# STAFF REPORT

SUBJECT: Keep West Subdivision – AZ, PP  
H-2023-0047

LOCATION: 2625 E. Lake Hazel Rd. and 6519 S. Raap Ranch Ln., in the NE 1/4 of Section 5, T.2N., R.1E. (Parcel # R7317670010 and R7317670020)

C. Preliminary Plat (dated: 2/15/24)

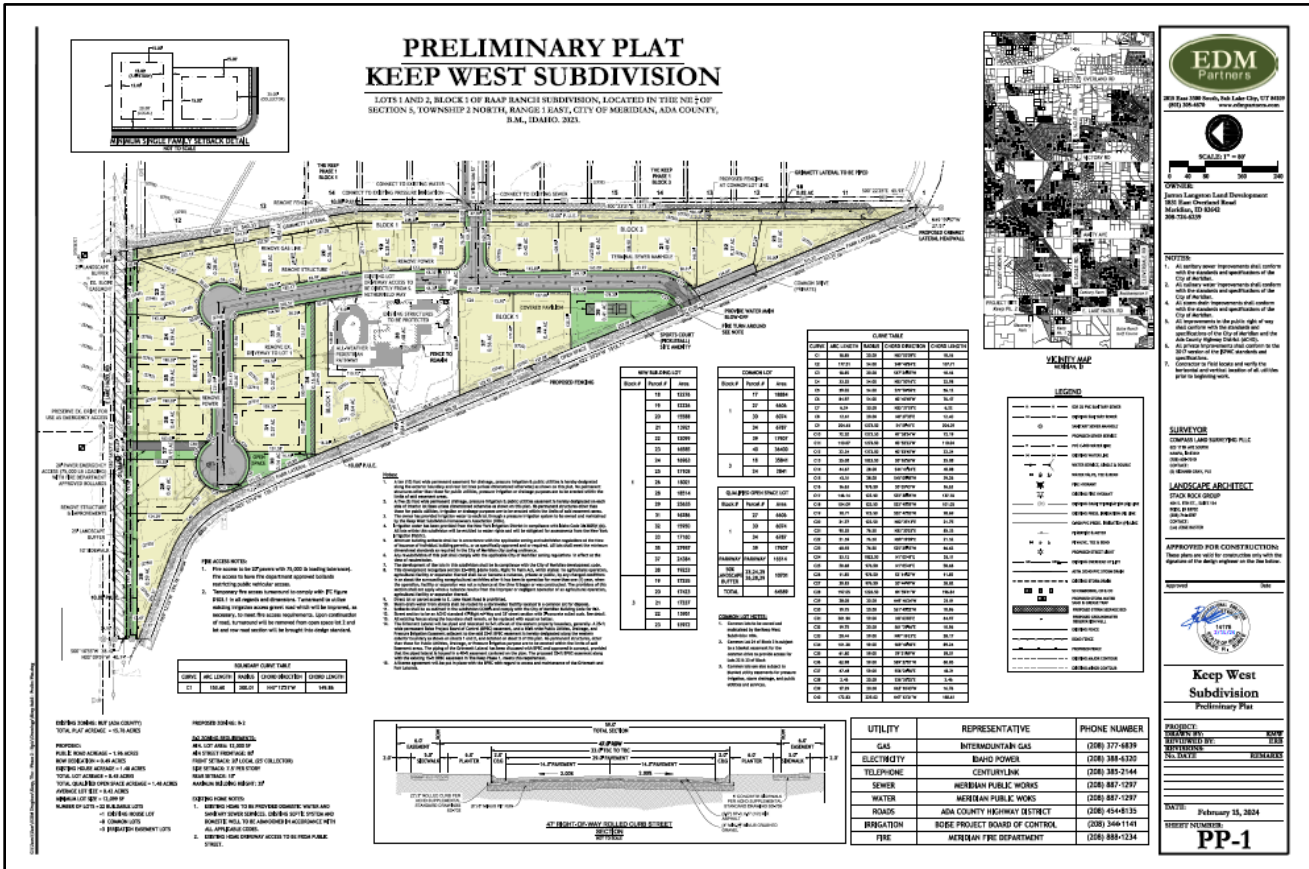
***The cul-de-sac for the proposed plat is greater than 900 feet which would exceed the maximum approval allowed by City Council of 750 feet in length. The applicant needs to revise the plat map shortening the length of the cul-de-sac and submit a revised plat map fifteen days prior to the City Council meeting.***

2. The final plat shall include the following notes and revisions:
    - a. Lots 27, 30 and 39, Block 1 are non-buildable common lots and will be owned and maintained by the Keep No. 2 Subdivision Homeowners Association.

- b. Place the landscape buffer along E. Lake Hazel Road in a common lot.
    - c. Identify the areas of the Farr and Grimmatt Laterals and the common drive as common lots on the plat.

7. **The applicant shall submit a revised plat map, fifteen days prior to the City Council meeting, showing the cul-de-sac does not exceed the required 750 feet in length.**

D. Common Driveway Exhibit (dated: 2/15/24)

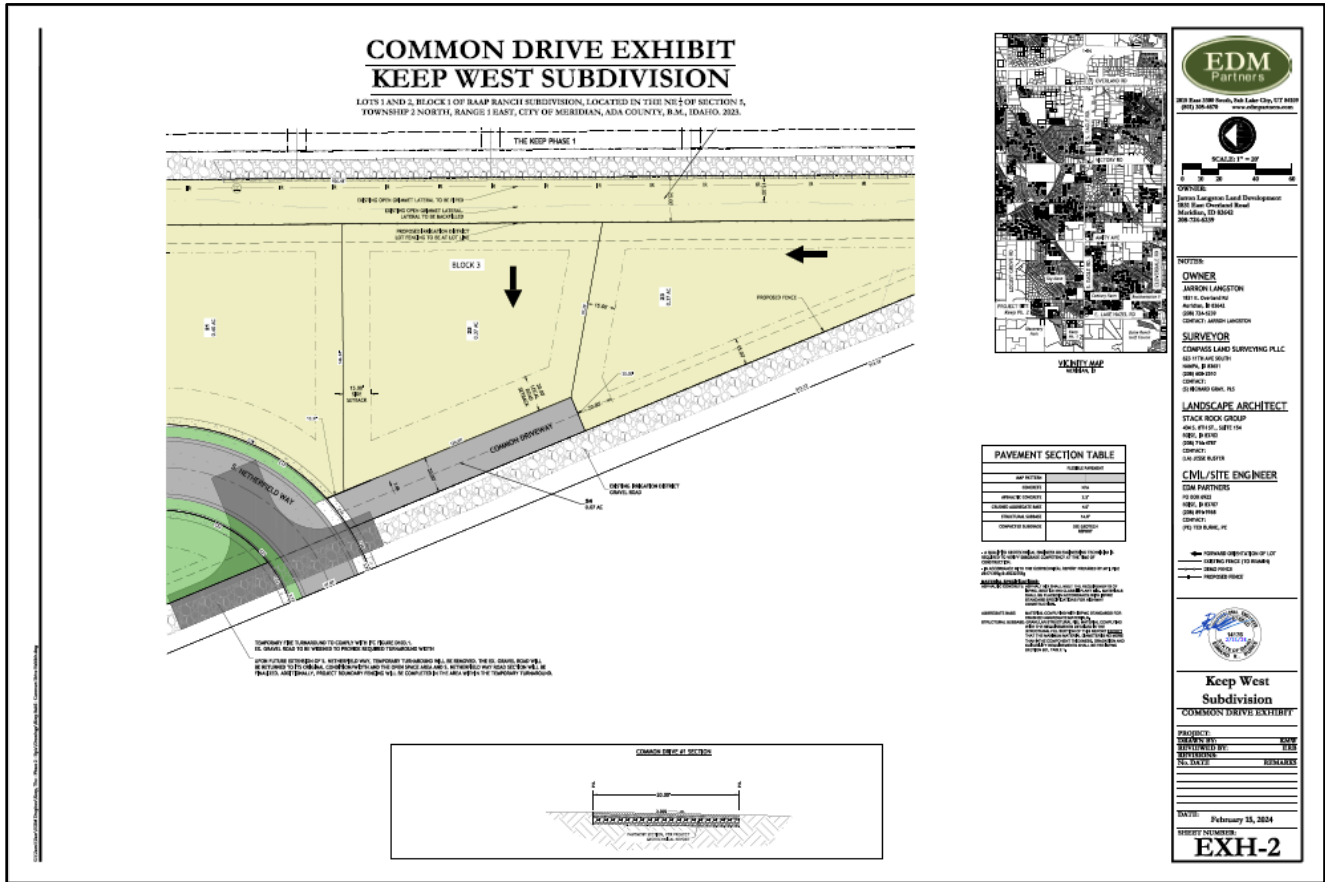
4. The common driveway for Lot 22 and 23, Block 3 shall comply with the standards listed in UDC 11-6C-3D and the exhibit in Section VIII.C.
  5. The address of the existing home shall change with development of the subdivision.

E. Landscape Plan (dated: 1/9/2024)

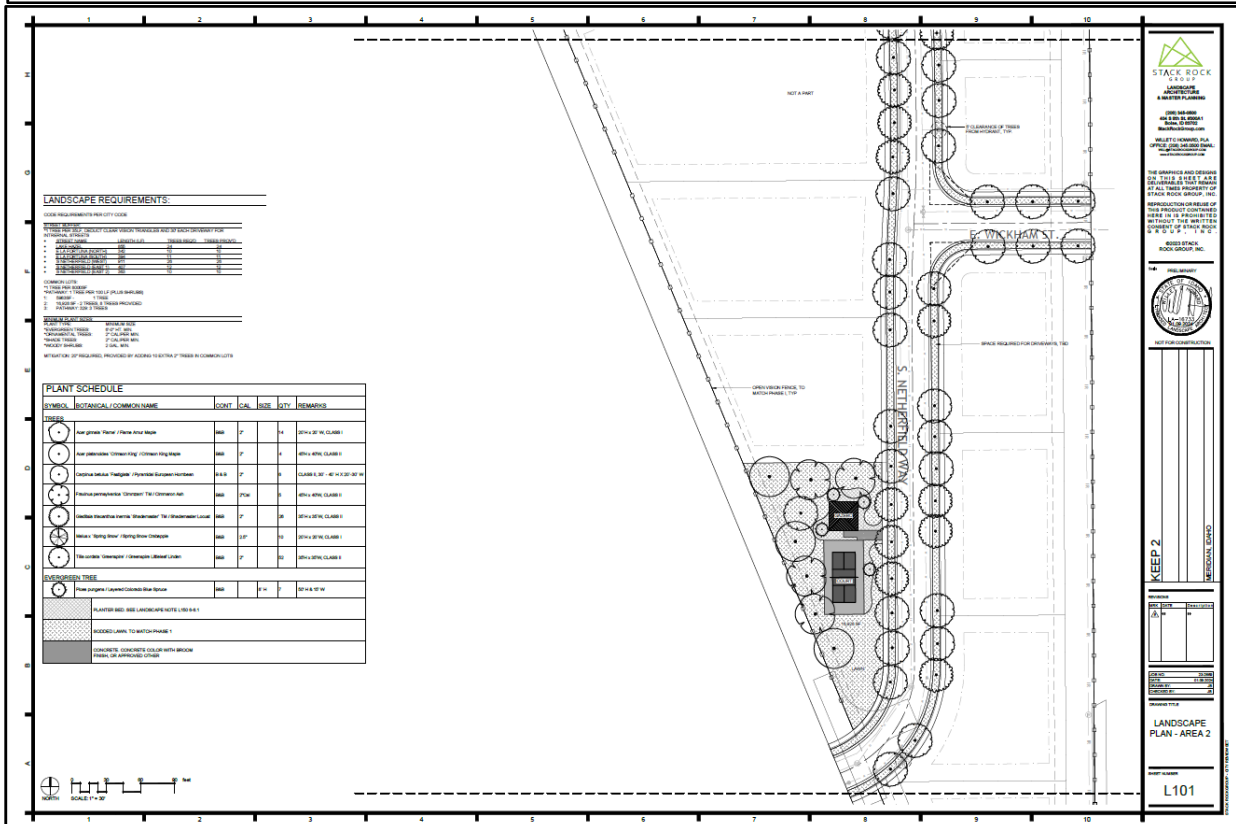
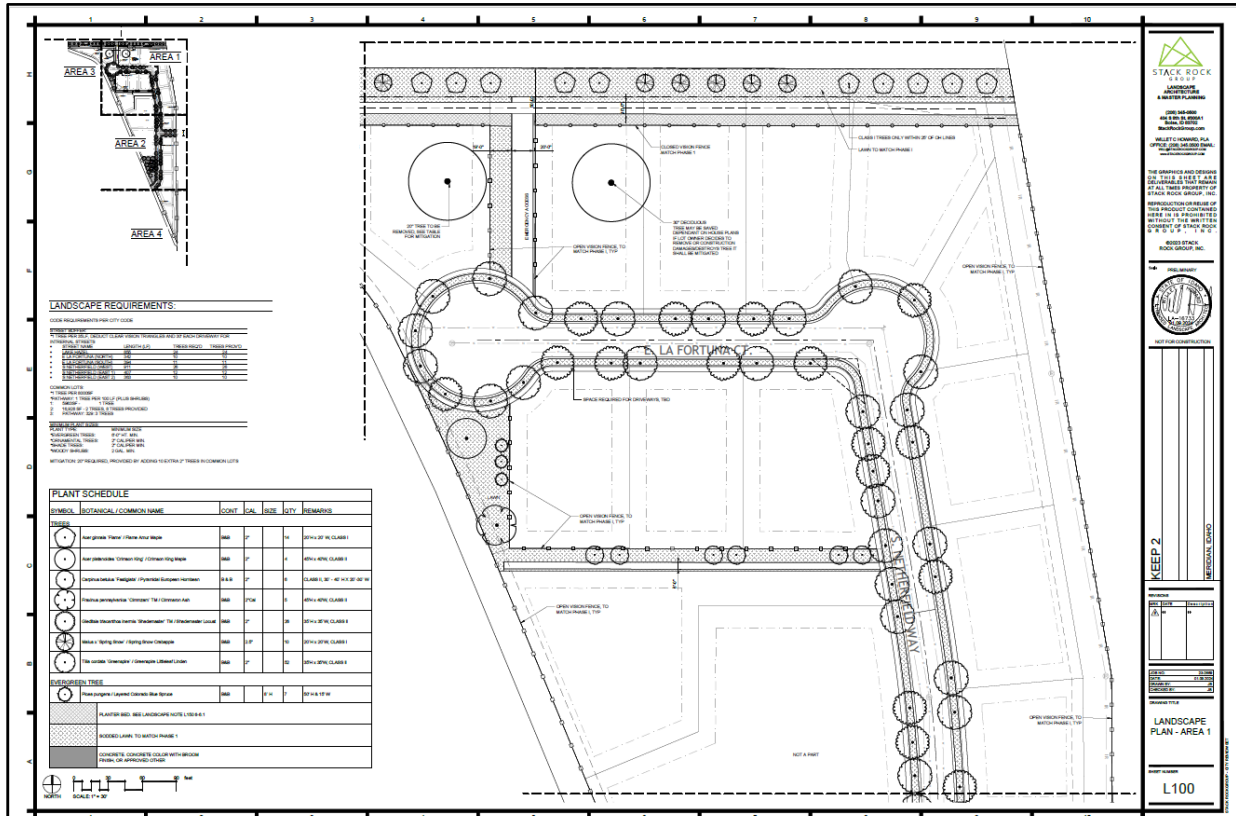
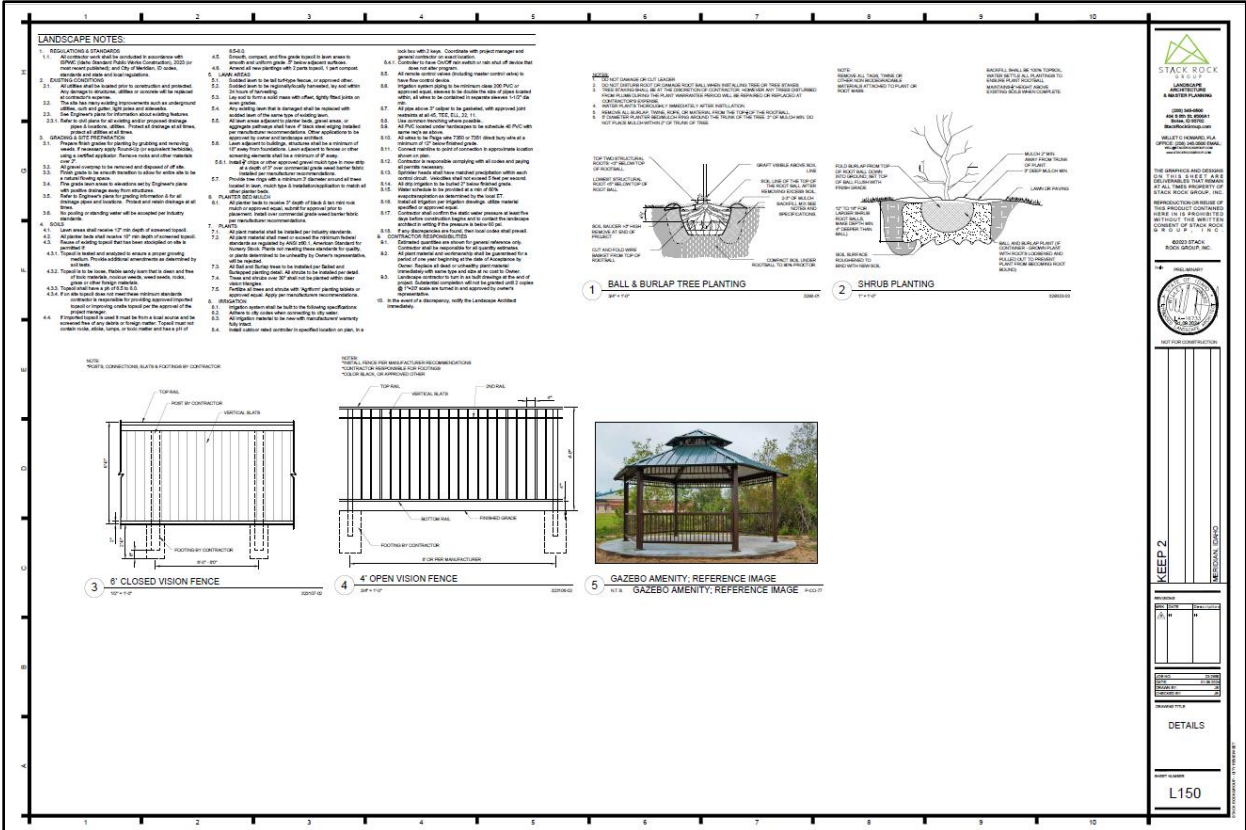
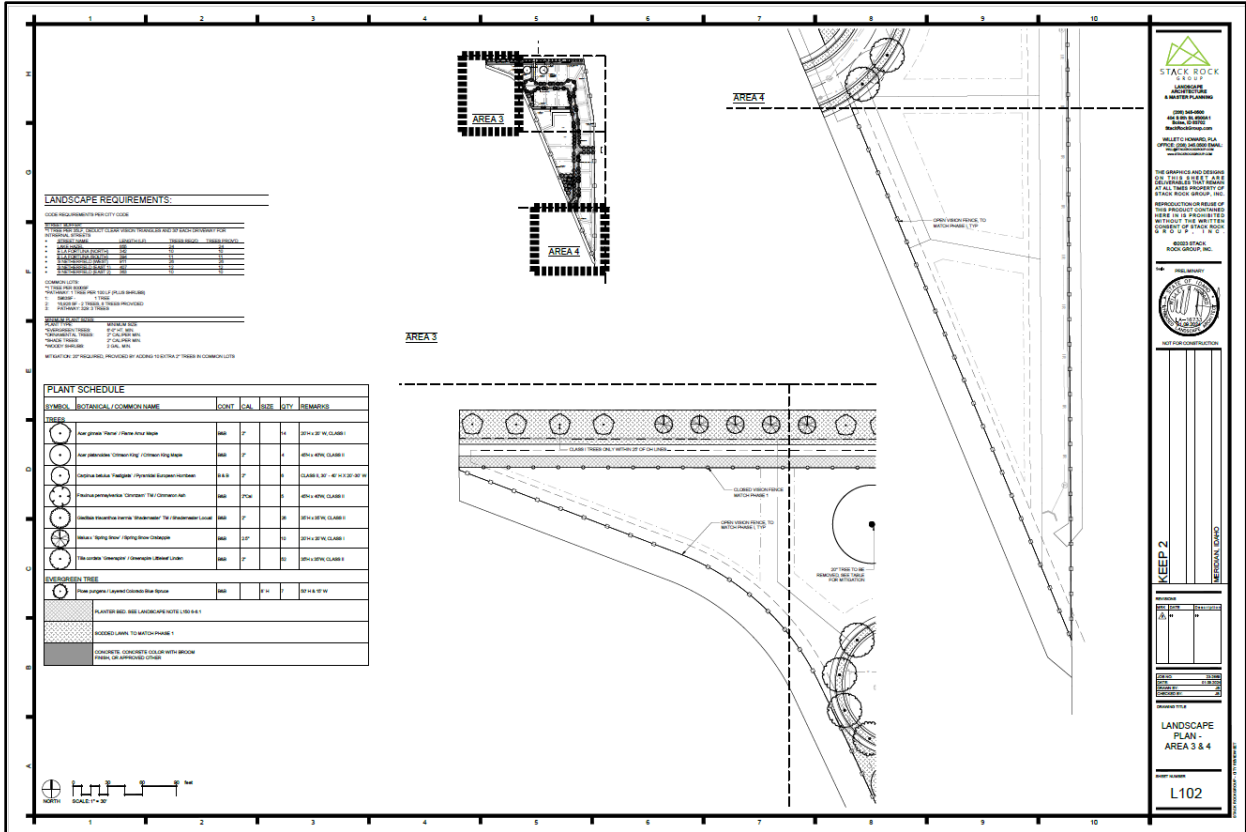
**There are several existing trees on the site, where possible existing trees should be retained. Mitigation is required in accord with the standards listed in UDC [11-3B-10C.5](#); calculations demonstrating compliance with the aforementioned standards should be depicted on the landscape plan.**

3. The landscape plan submitted with the final plat shall include the following revisions:
    - a. Include mitigation information for all existing trees being removed from the site in accord with the standards listed in UDC 11-3B-10C.5.

- b. Provide landscaping along both sides of the pathway per UDC 11-3B-12.C
    - c. Extend the pathway on Lot 34, Block 1 to the cul-de-sac instead of having it dead end at Lot 40, Block 1.
